May 28, 2019

IDEA PUBLIC SCHOOLS  
IDEA EDINBURG CAMPUS PHASE III

## **ADDENDUM NO. 1**

01 LIGHTING PLAN (GYM)

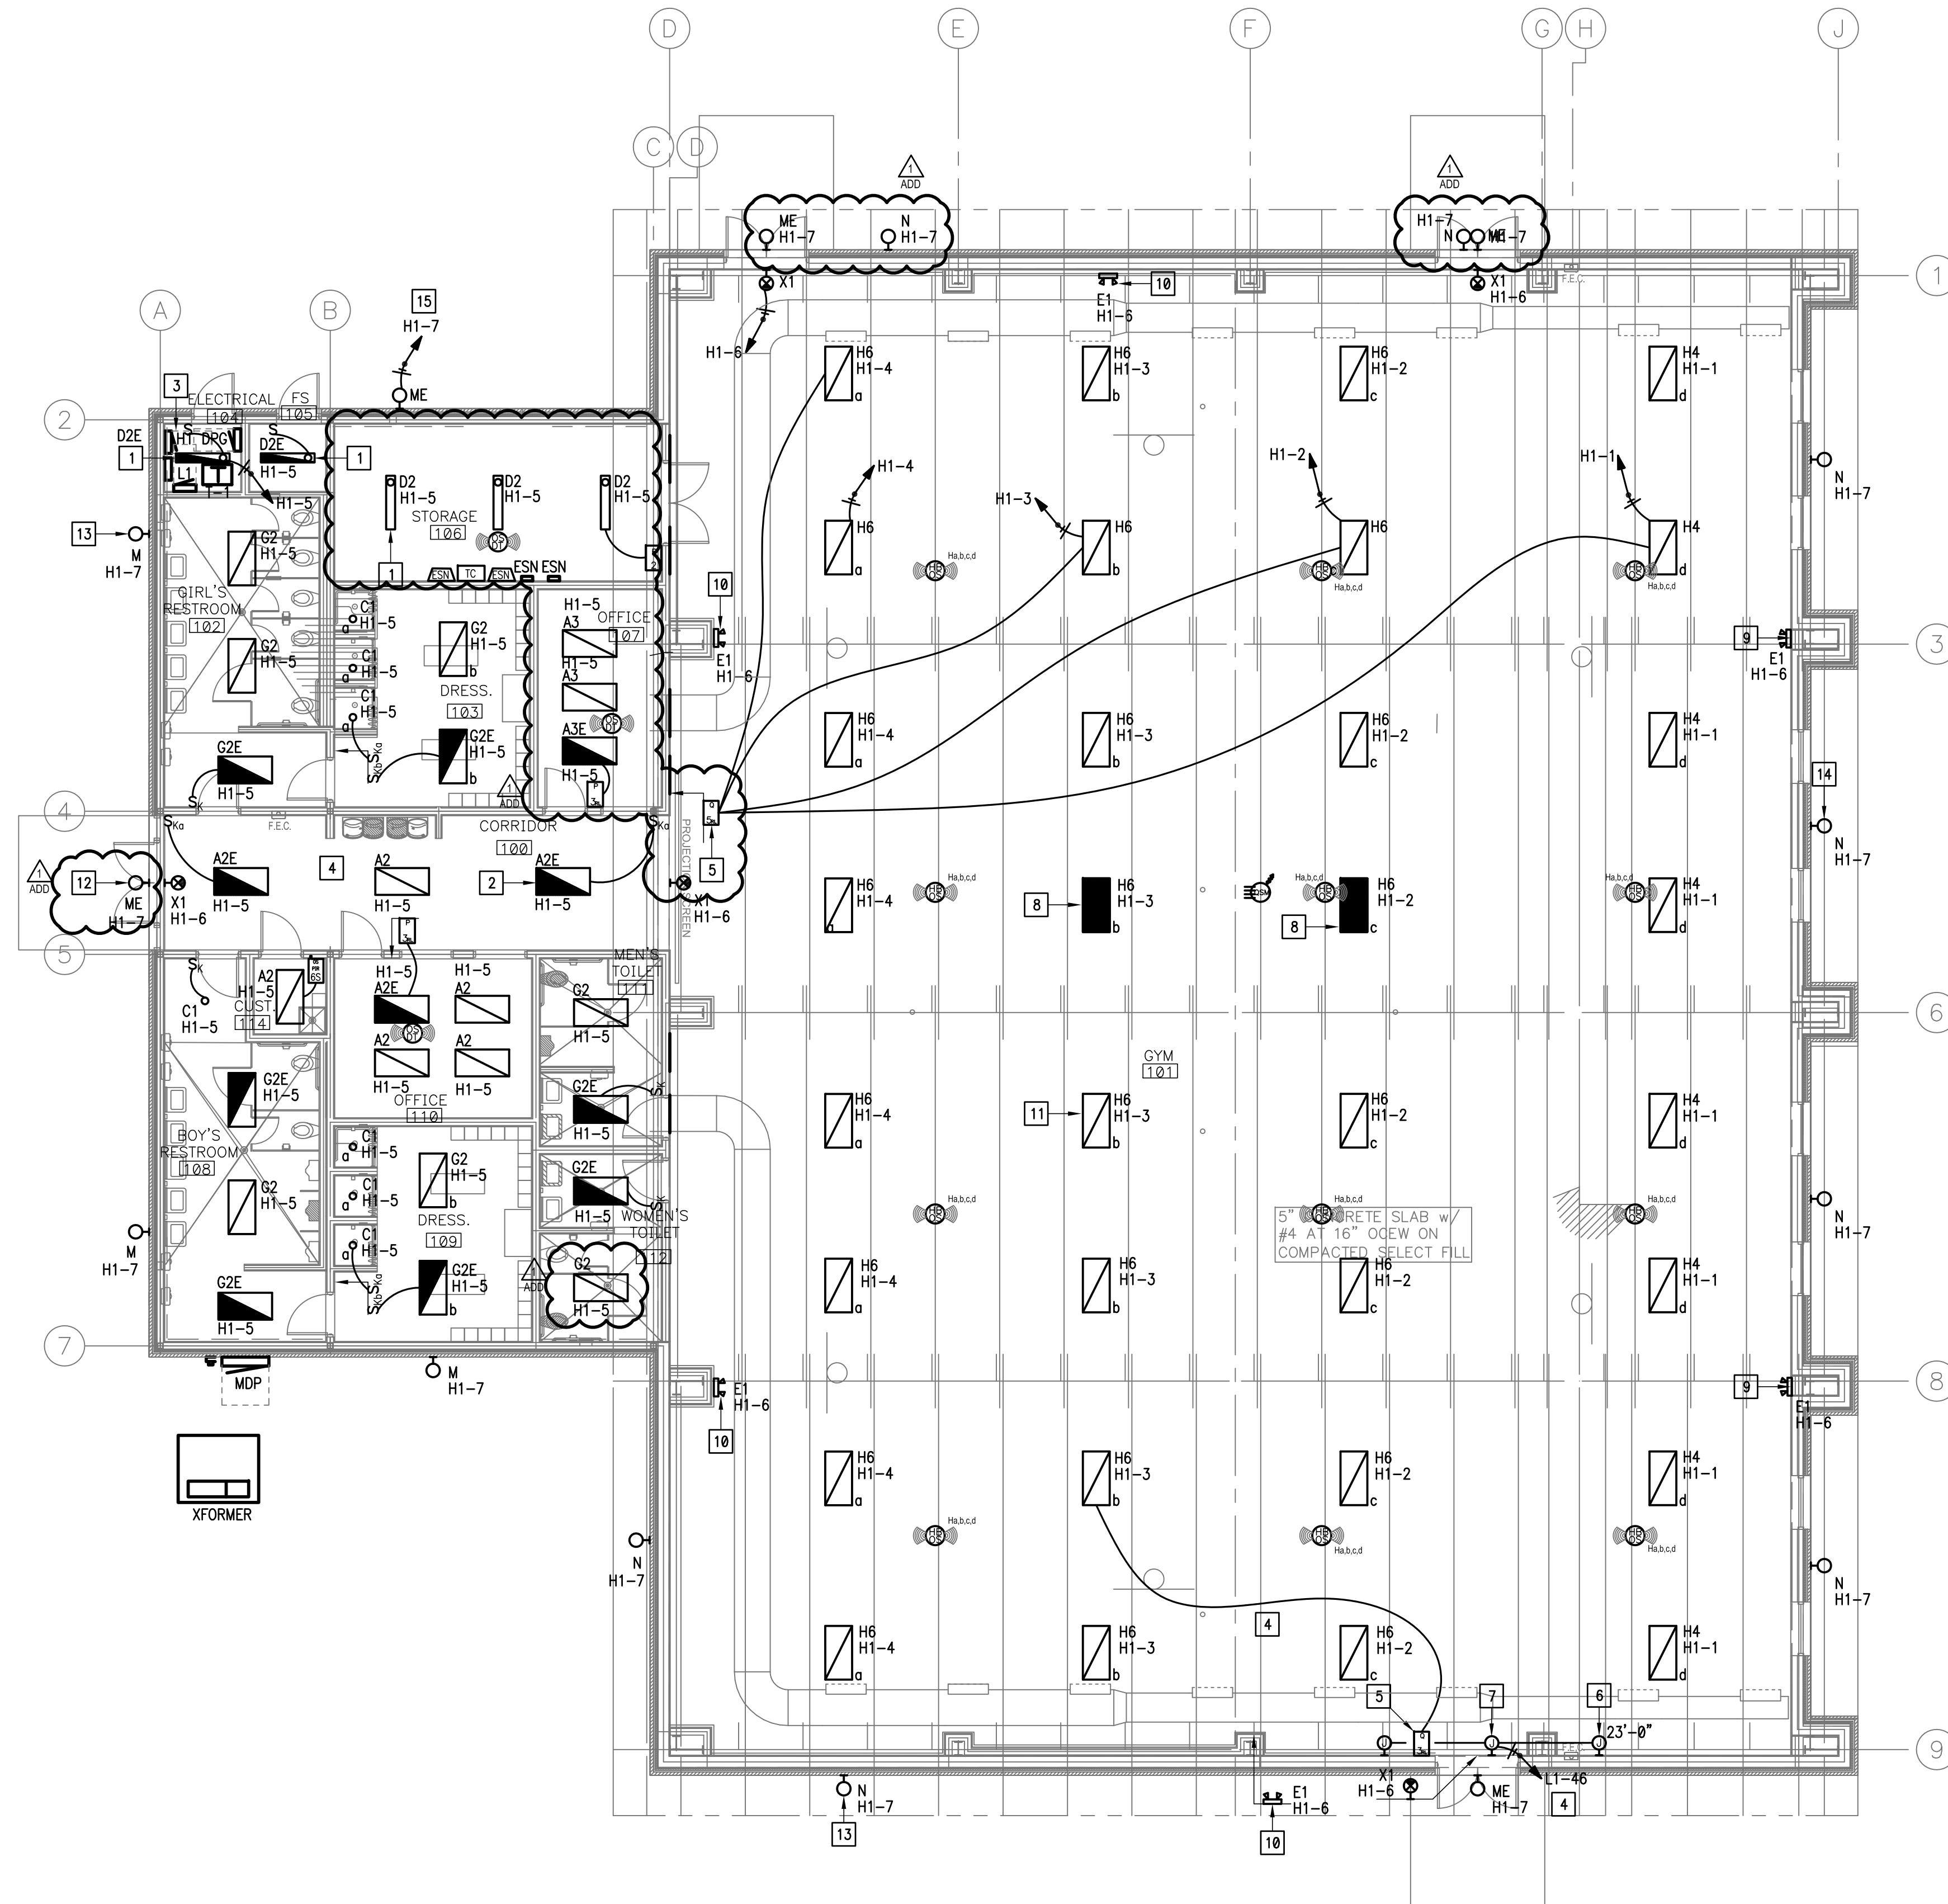
- a) Revised Mechanical Elevations. See attached sheet.
- 4) Sheet E2.01:
  - a) Revised Electrical Scope of Work and Symbols Legend. See attached sheet.
- 5) Sheet E3.01:
  - a) Revised Lighting Plan. See attached sheet.
- 6) Sheet E4.01:
  - a) Revised Luminaire Schedule. See attached sheet.
- 7) Sheet E5.01:
  - a) Revised Electrical Riser Diagram and Schedules. See attached sheet.
- 8) Sheet E6.01:
  - a) Revised and Added Electrical Details. See attached sheet.
- 9) Sheet P2.01:
  - a) Revised Plumbing Plan. See attached sheet.
- 10) Sheet P3.01:
  - a) Revised Waste & Vent Plan. See attached sheet.
- 11) Sheet P5.01:
  - a) Revised Plumbing Schedule. See attached sheet.
